20 December 2019

### **Ruby Bay Drainage Issues**

Figure 1

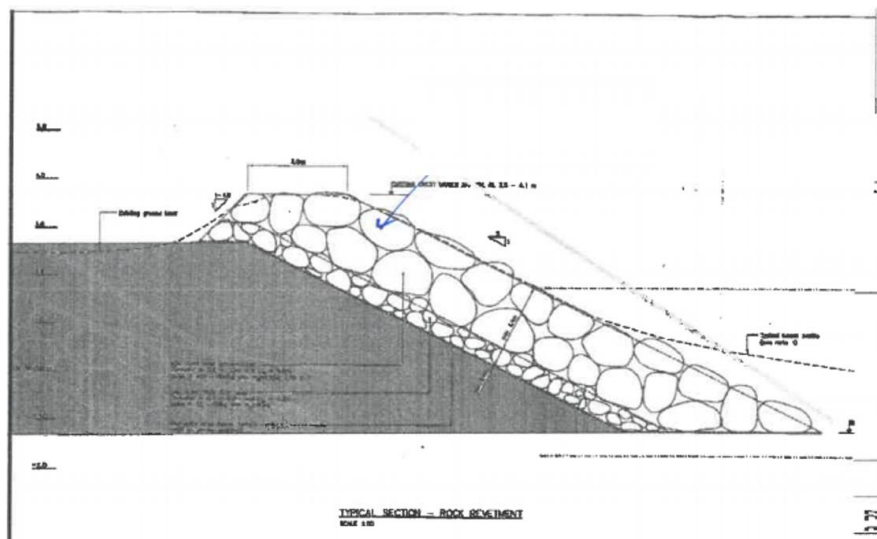
Attendees presented a drawing which showed the sea wall design as per below (Figure 1). Attendees were of the view that this was a cross section as per the resource consent for the sea wall. They suggested that if the wall was built as per this design then water could flow back through the wall via the voids between the rocks.

The attendees suggested that penetrations through the sea wall, or sections of wall reconstructed out of large rocks with voids between, could be installed at strategic locations to allow water to drain from behind the sea wall. One attendee suggestion was to locate these penetrations/ sections of large rock at the ends of the alleyways running from Broadsea Ave, and at the end of Tait St. They also suggested that the boat ramp in Chaytor Reserve was a potential location where water could drain away back out to sea if the top of the ramp was lowered and the reserve area regraded.

Council response: The existing wall is compliant with its resource consent as detailed in the Engineering Services Committee report dated 4 July 2019. (The existing wall is similar in construction to Figure 2.) No reconstruction or major changes to the existing clay core wall was envisaged or planned as part of the process for the current resource consent.

The Council's Coastal Scientist, and Rivers & Coastal Engineer, have assessed the proposal to introduce voids into the existing clay core. They are both of the opinion that in an event like ex-cyclone Fehi the ability for seawater behind the wall to drain back through any voids will be less than the quantity of water surging over the wall and through the voids. They consider it is likely that introducing voids would result in more seawater getting behind the wall during the event. Reconstructing the wall to introduce voids would involve significant work and expense. A thorough investigation would be required to evaluate this proposal in detail.

Figure 2

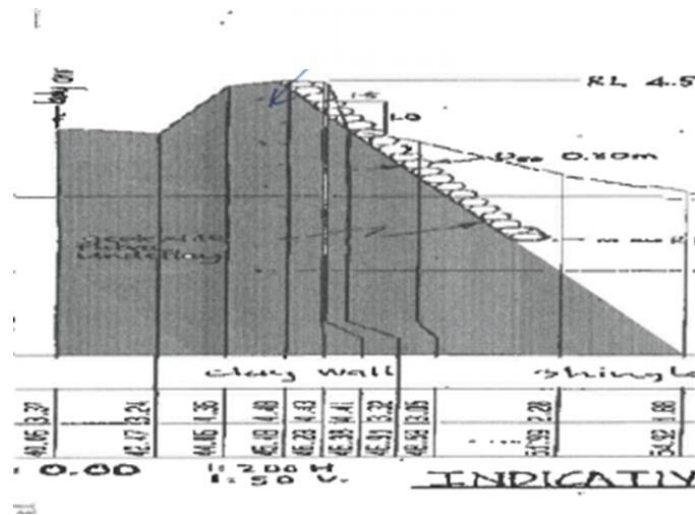
Attendees also presented another drawing (Figure 2 below) which more closely represents the current sea wall construction. They indicated that this was from the old resource consent which had expired. This shows a clay core wall with rock armour over.
